**ADMINISTRATIVE RECORD  
FOR THE MADISON SITE  
MADISON, ILLINOIS**

Written Public Comments and Corresponding Responses  
to Comments

SUBJECT: Transmittal of USACE Responses to IDNS Comments on the Final Madison Site Remedial Investigation/Feasibility Study and Proposed Plan, January 2000

**DOSE ASSESSMENT FOR DIFFICULT-TO-ACCESS AREAS**

Figure 1. Approximate Sample Locations for Difficult to Access Areas

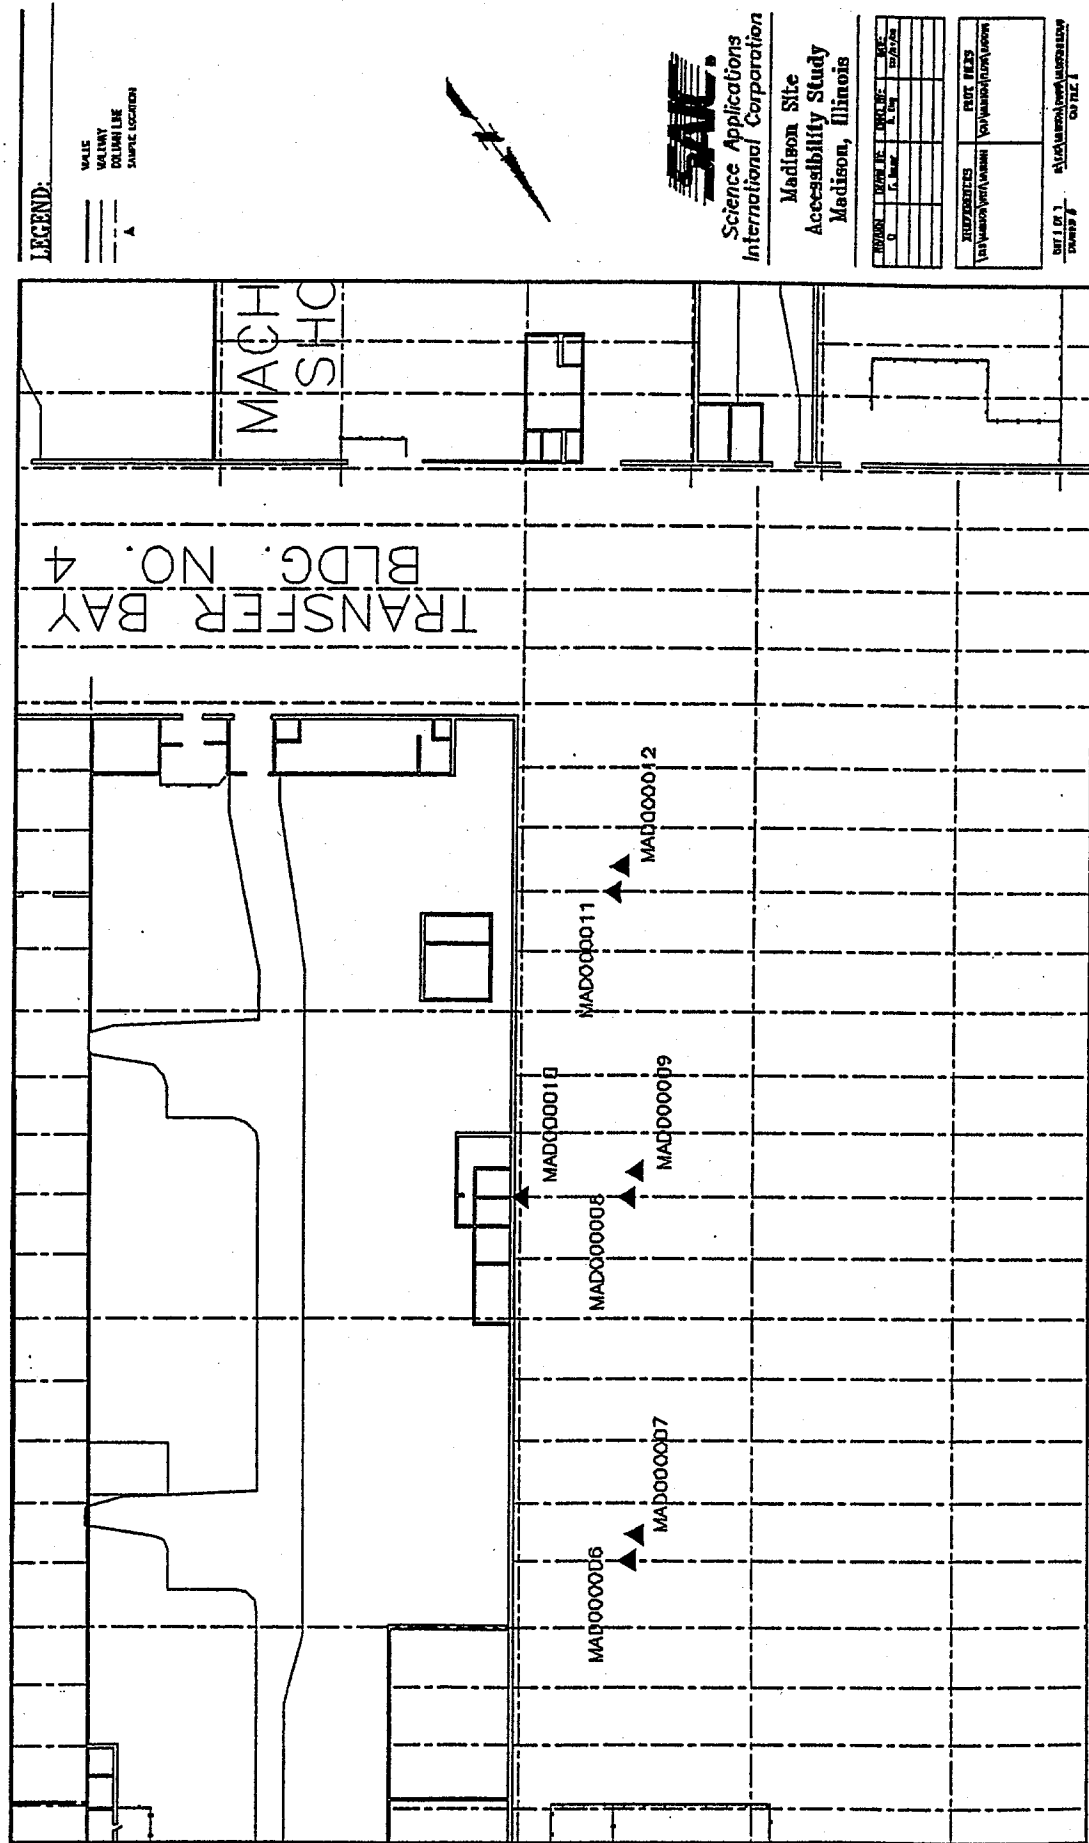
*Comment 9*—The Department is encouraged that the Corps has collected additional samples to further characterize contaminated areas. The first step described in decommissioning guidance is the characterization of the radioactive contamination ("source term" or "source"),

upon which all subsequent assessments are based. The Department has not been satisfied with the source characterization at the Madison facility, due to the invalidated assumptions of contamination levels at the upper tiers of the facility. The Department hopes that the Corps has now collected the samples necessary to demonstrate statistical representation of all contaminated areas. The Department is withholding a determination on this issue until the new sampling results and statistical analyses have been documented by the Corps.

*Response 9*—USACE has completed additional sampling and performed a supplemental risk assessment of the Difficult-to-Access Areas. The results of this assessment are enclosed. (Attachment 1).

The beam/sample locations presented in Table 1 are shown in Figure 1. Figure 1 is based on the hand-drawn map used by field personnel during the sampling event. Figure 1 is not drawn to scale, but does illustrate the distribution of sampling locations in relation to previous sampling events and the extrusion press. For a comparison to previous sampling locations and concentration results (from lower/accessible beams in the study area) see Figure 1-4 from the Feasibility Study (USACE 2000).

Figure 1. Approximate Sample Locations for Difficult to Access Areas

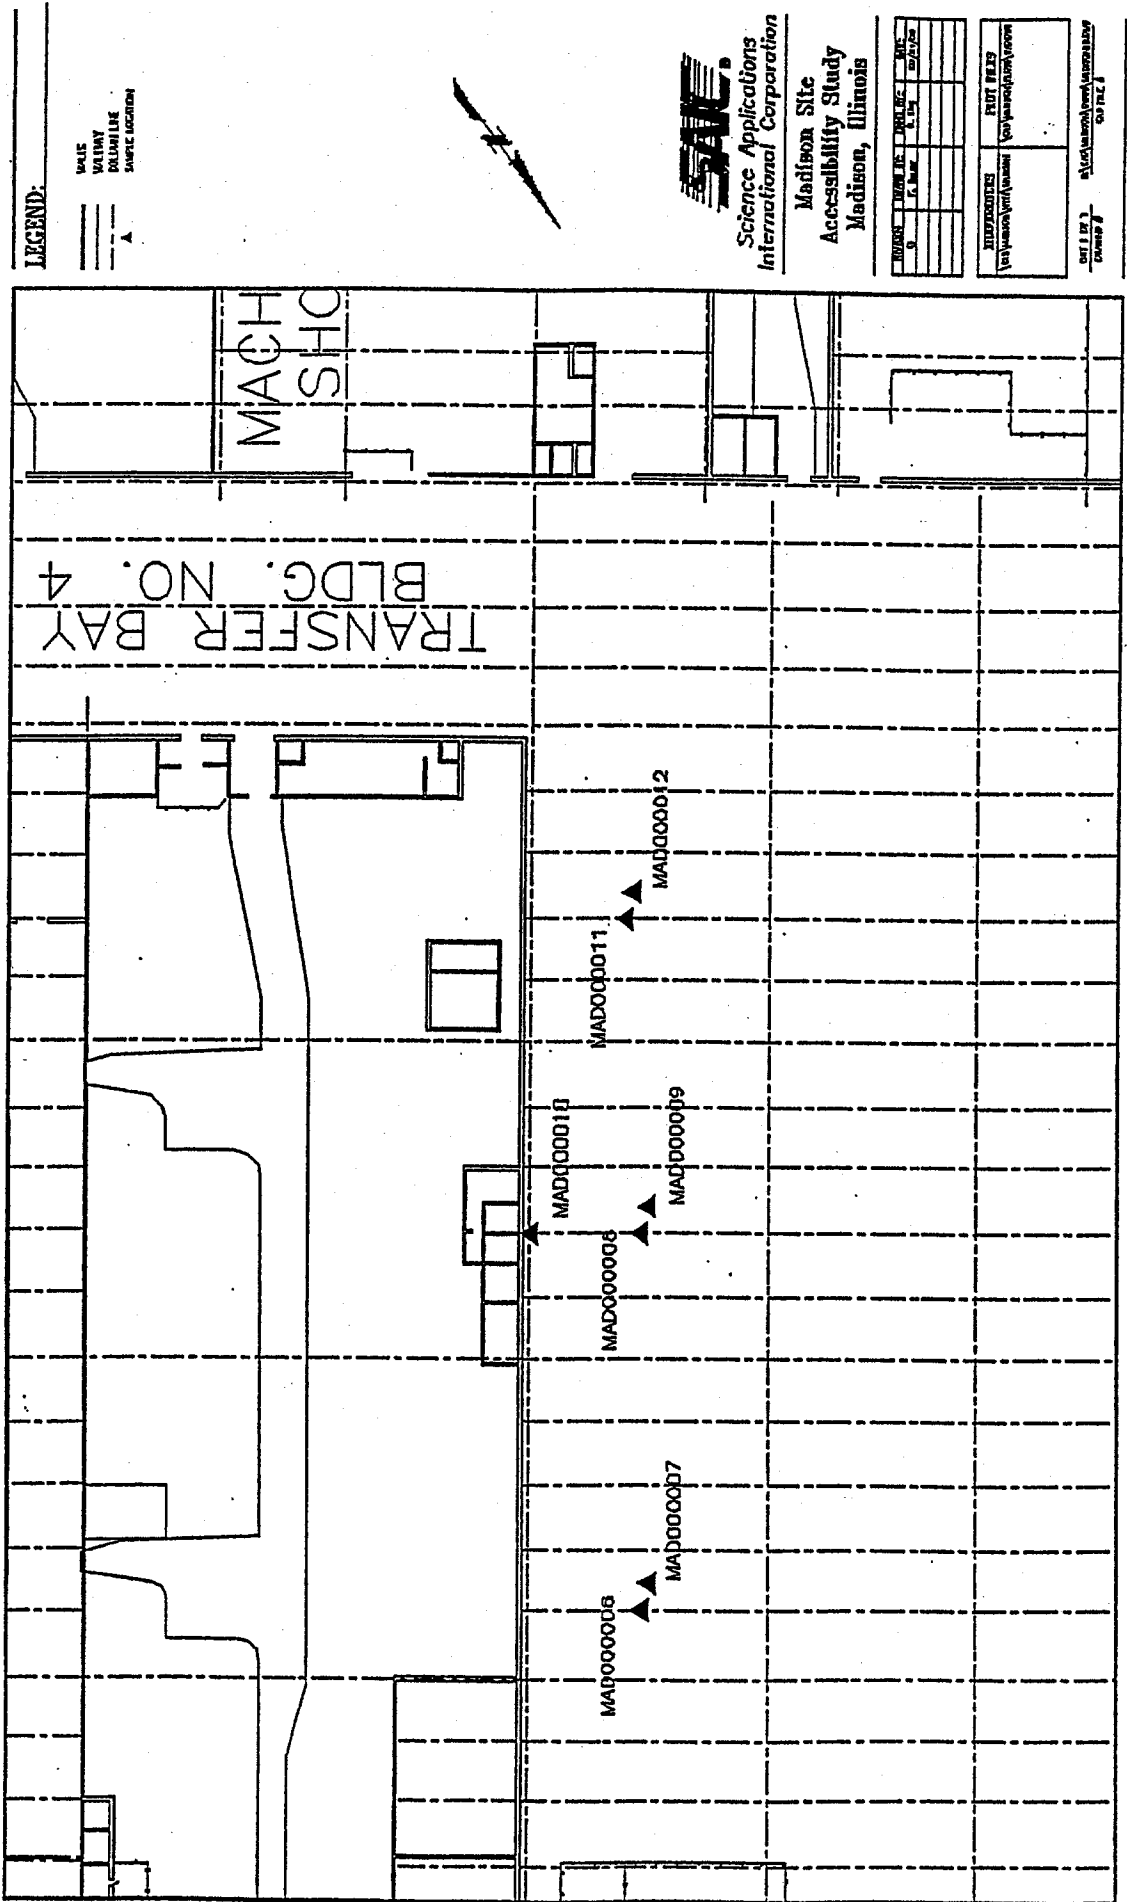
*Comment 9*—The Department is encouraged that the Corps has collected additional samples to further characterize contaminated areas. The first step described in decommissioning guidance is the characterization of the radioactive contamination ("source term" or "source"),

*Response 9*—USACE has completed additional sampling and performed a supplemental risk assessment of the Difficult-to-Access Areas. The results of this assessment are enclosed. (Attachment 1).

The beam/sample locations presented in Table 1 are shown in Figure 1. Figure 1 is based on the hand-drawn map used by field personnel during the sampling event. Figure 1 is not drawn to scale, but does illustrate the distribution of sampling locations in relation to previous sampling events and the extrusion press. For a comparison to previous sampling locations and concentration results (from lower/accessible beams in the study area) see Figure 1-4 from the Feasibility Study (USACE 2000).
